ICHD–ENVIRONMENTAL HEALTH DIVISION PTB

Statesville Office (704) 878-5305 Mooresville Office (704) 660-3625 PERMIT # 208737

SEPTIC IMPROVEMENT PERMIT / AUTHORIZATION TO CONSTRUCT / OPERATION PERMIT / EXISTING SYSTEM

SITE ADDRESS: 131 Farm Knoll Way Mooresville NC PHONE: 704 283 1229 ALT. PHONE Kenny 704 502-5588

INITIAL SITE SKETCH

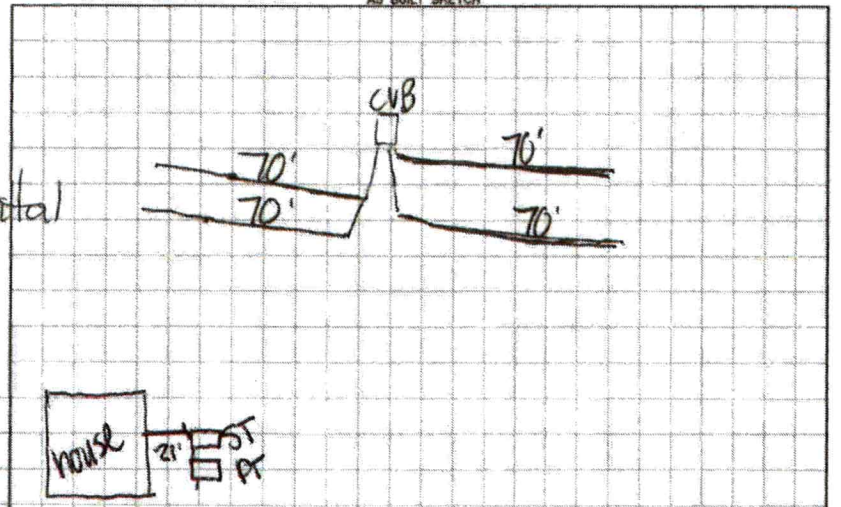
Comments / Conditions: 359ft of drainfield was flagged, however 267ft is required
Keep tanks 15ft from Basement.

Ok to switch drive to other side.
5/32 used -set pressure at 3'

AS BUILT SKETCH

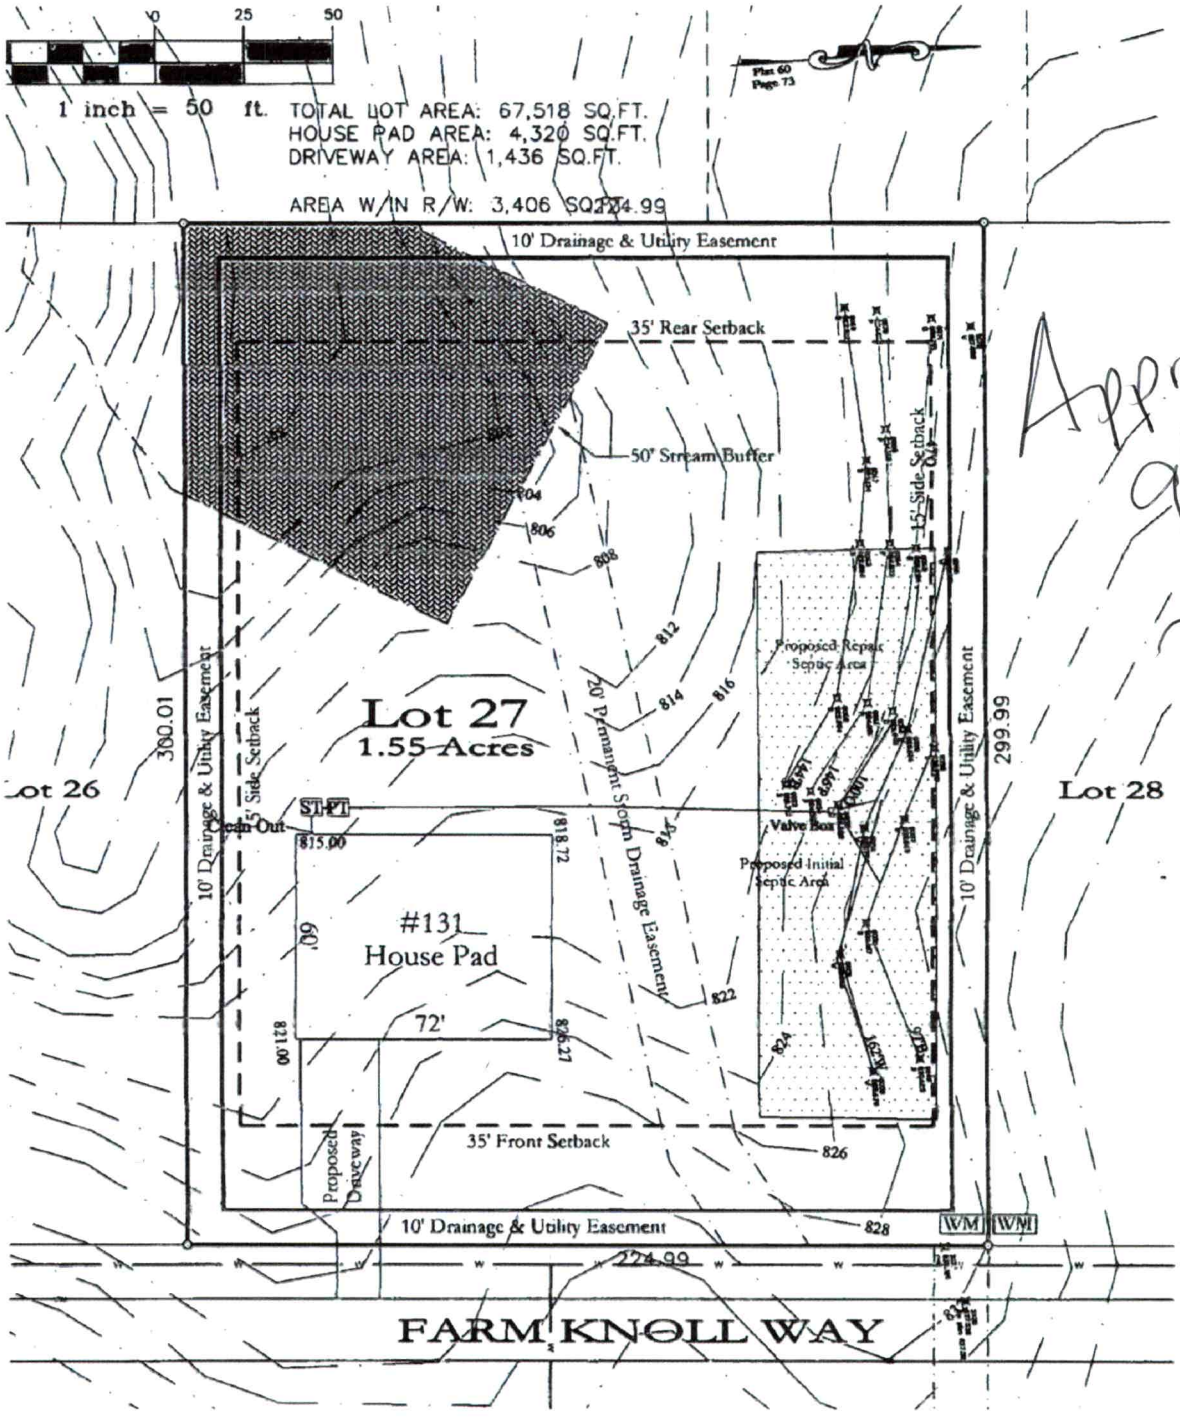
4/2: -irrigation lines within 10' of tanks → must be disconnected + verify before issuing OP ✓
4/13: irrigation lines relocated to 10' from tanks
